NOTICE OF ADDENDUM

ADDENDUM NO. 2

CITY OF MADISON
NAKOOSA TRAIL FLEET/FIRE/RADIO SHOP FACILITY

C-102

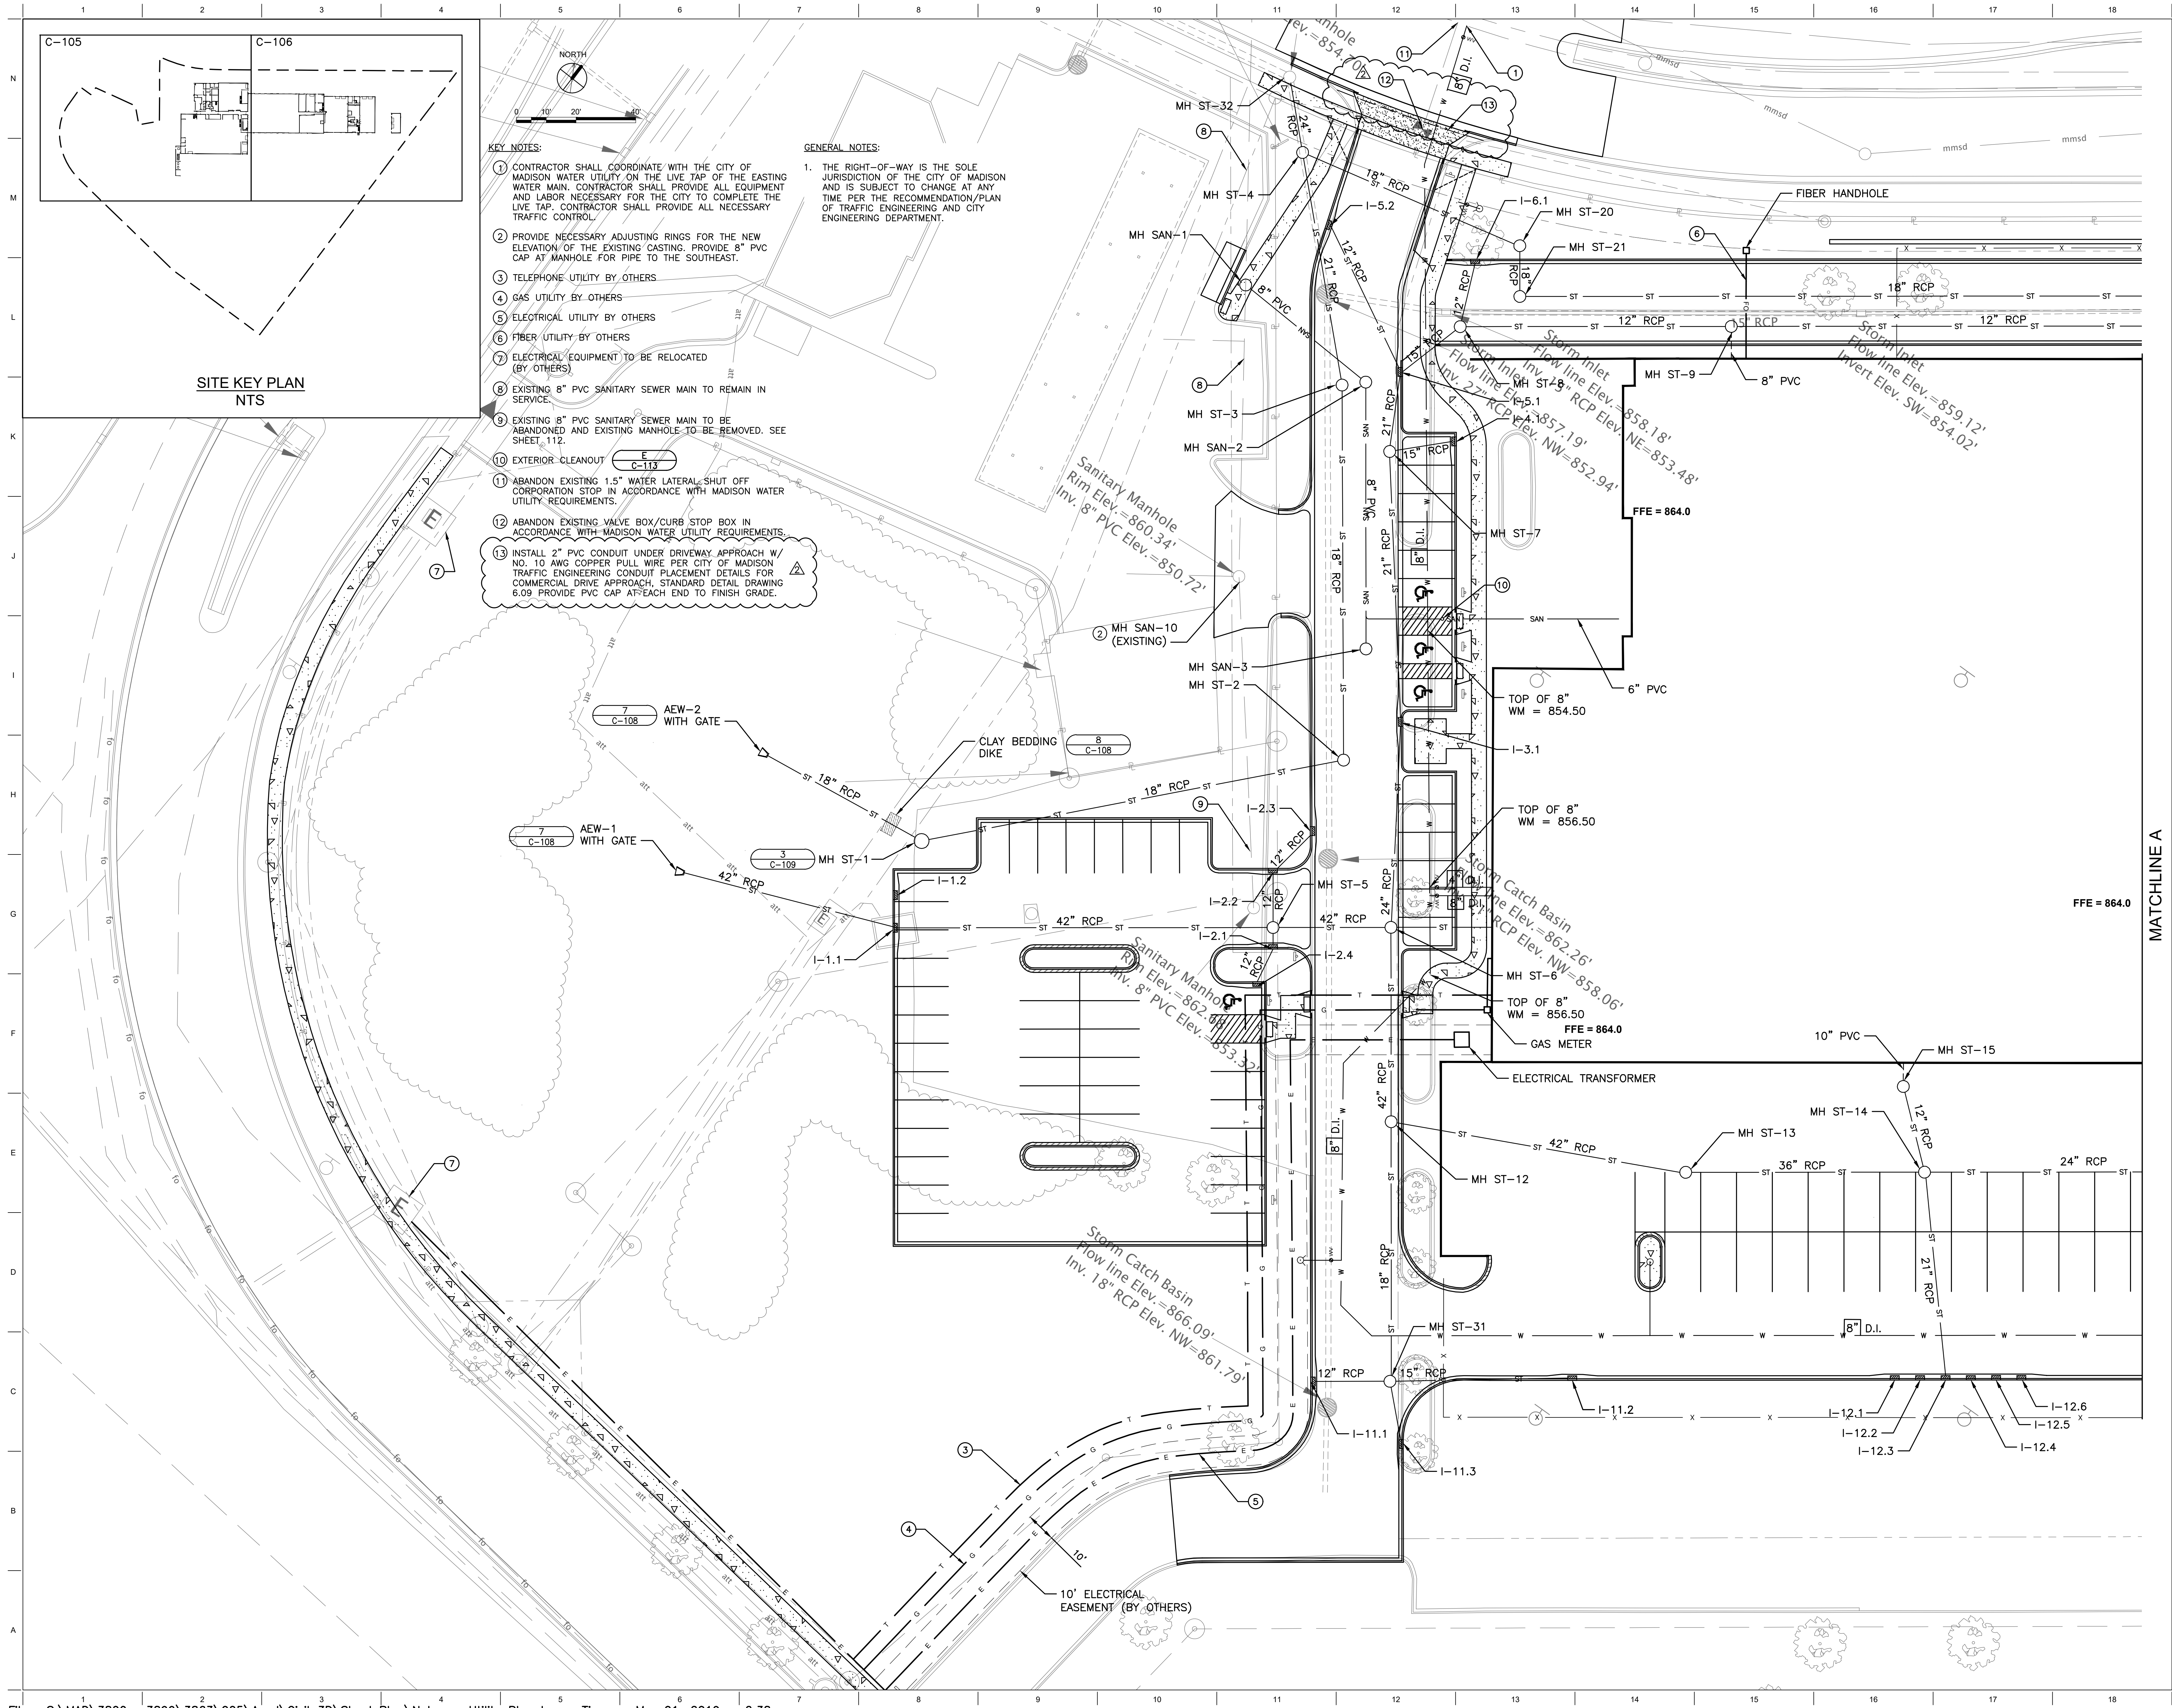
- E. **MODIFIED** C-102 SITE PLAN to include modular block retaining wall elevations along Nakoosa Trail, the length and elevation of the field stone retaining wall, labeling of contours on the drawing, and an addition to the Legend.

C-105

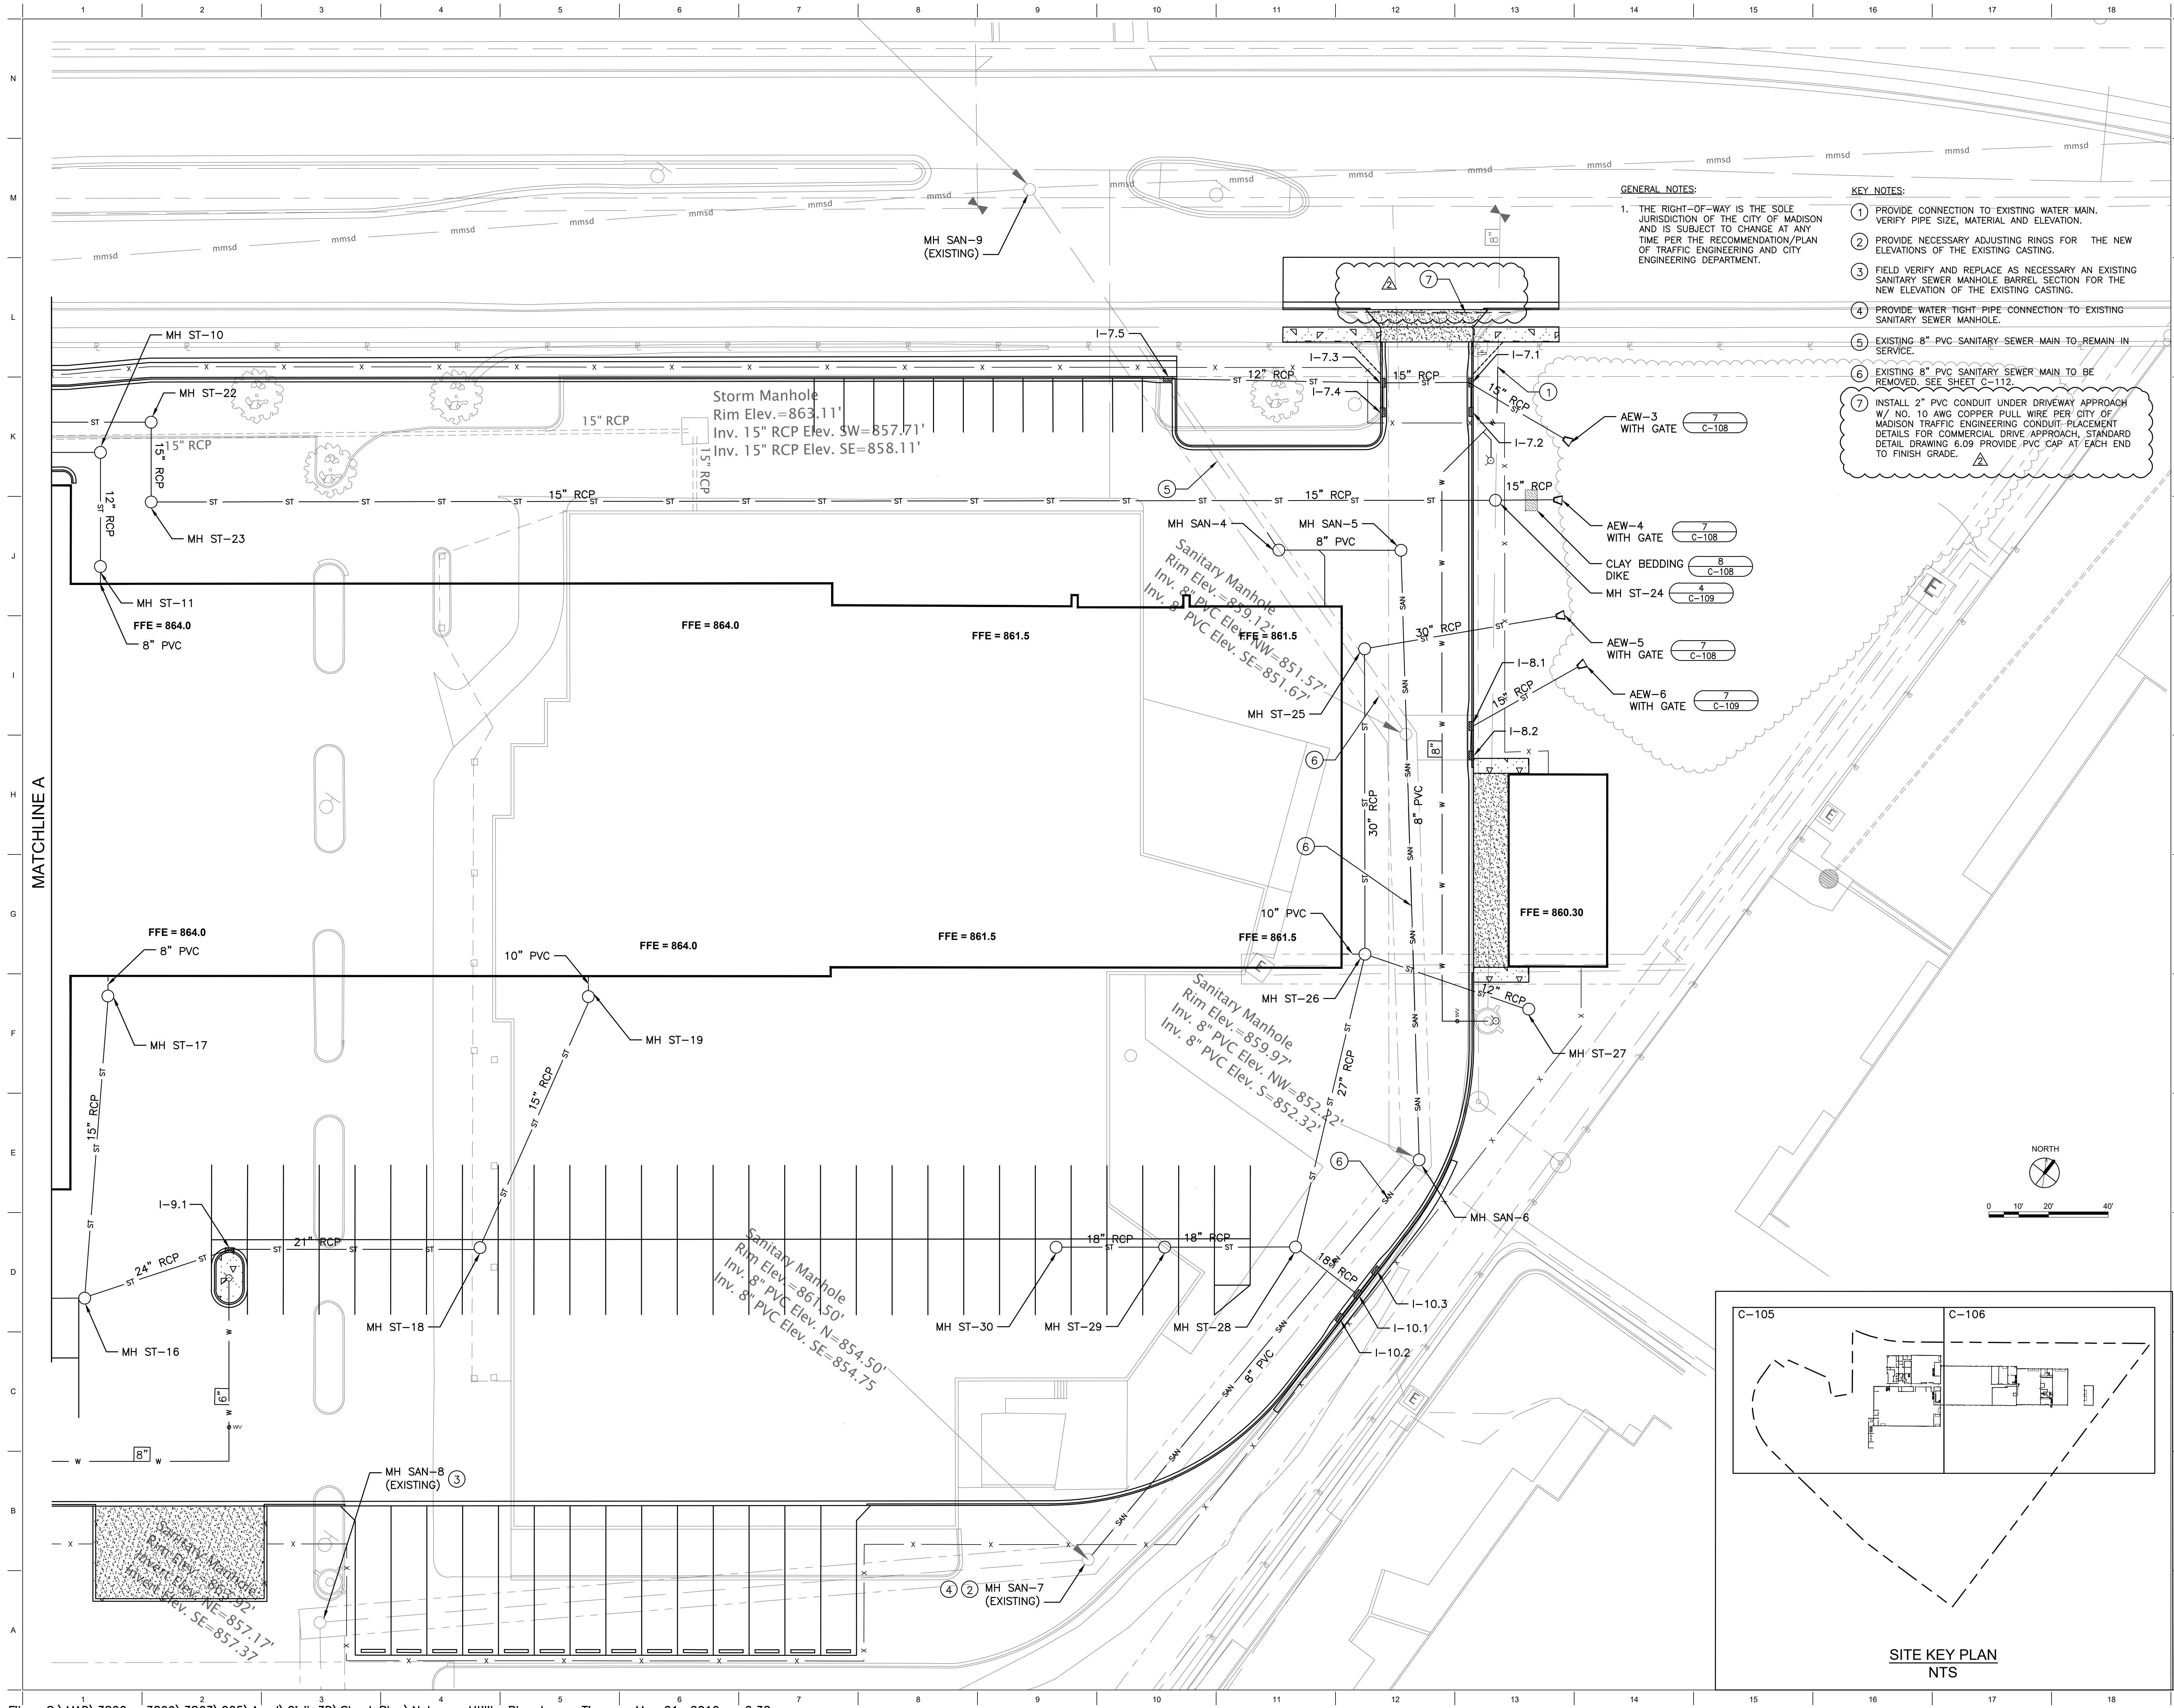
- F. **MODIFIED** C 105 UTILITY PLAN to include Key Note 13 and the location of the 2-inch PVC conduit under the commercial driveway approach.
- G. **MODIFIED** C-106 UTILITY PLAN to included Key Note 7 and the location of the 2-inch PVC conduit under the commercial driveway approach.

L-201

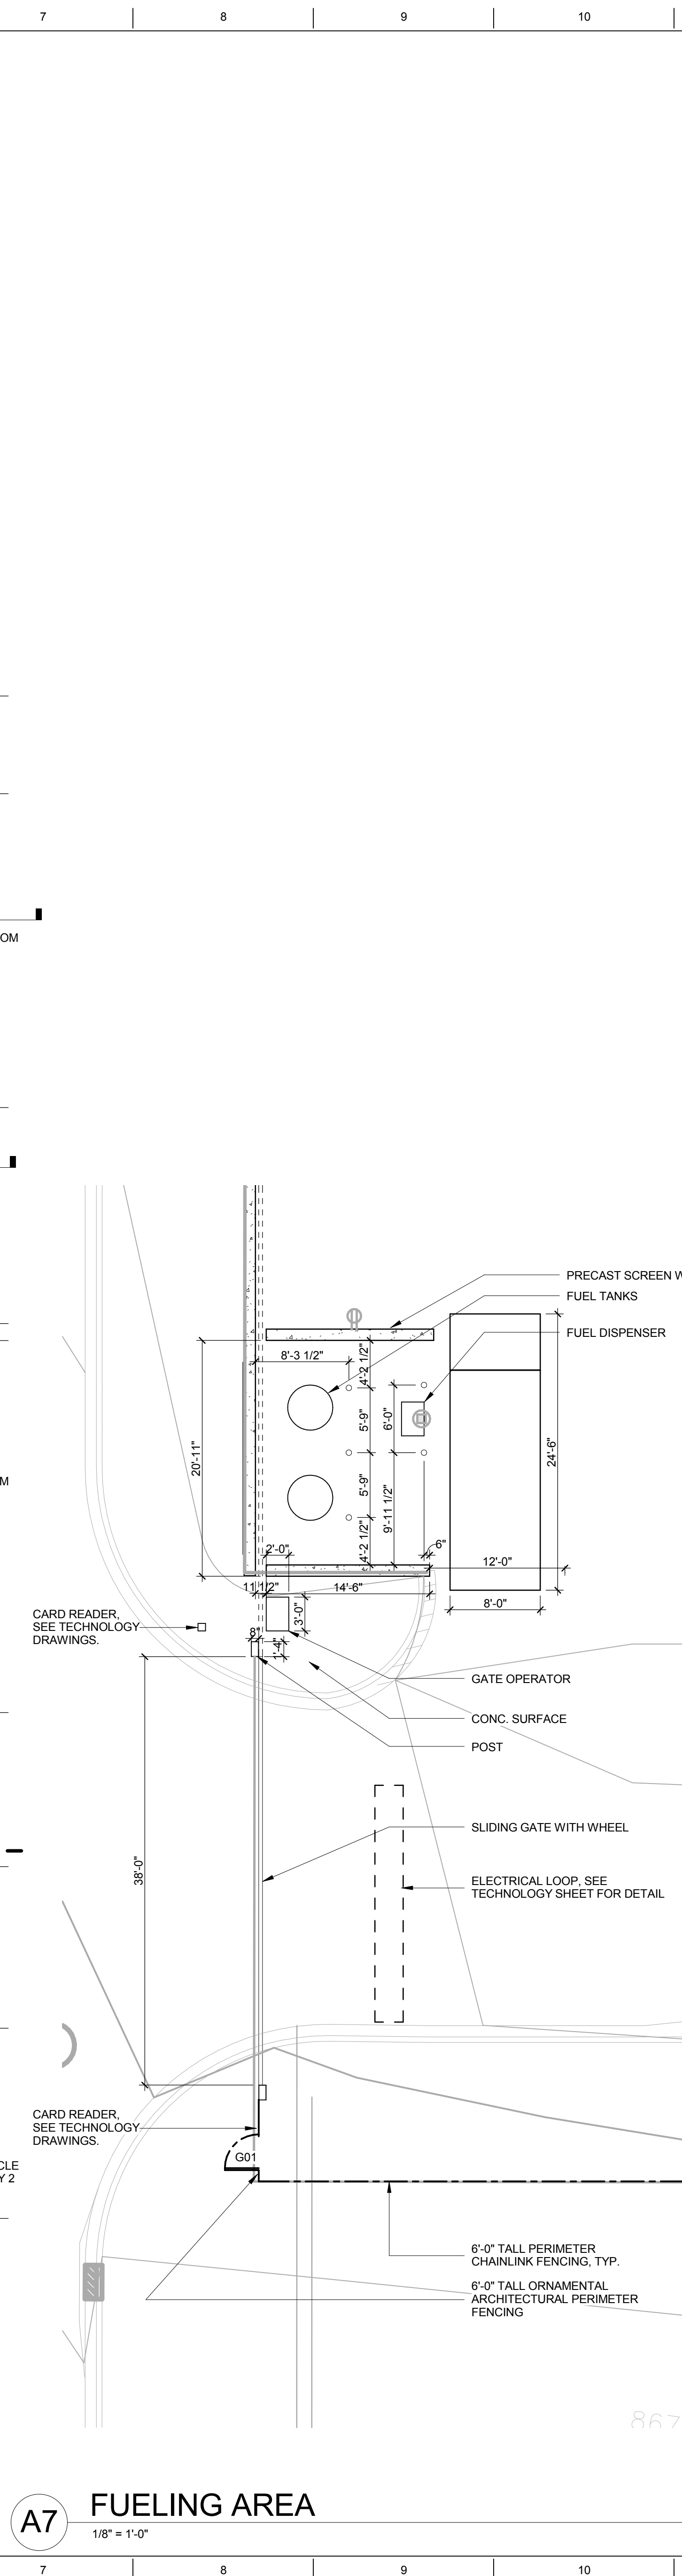
- H. **MODIFIED** C-112 DEMOLITION PLAN to include General Note 2.
- I. **MODIFIED** C-113 STANDARD DETAILS to include detail L.
- J. **MODIFIED** L-201 LANDSCAPING PLAN to included grading at the western detention basin and removal of a portion of the western end of the modular block retaining wall along Nakoosa Trail.
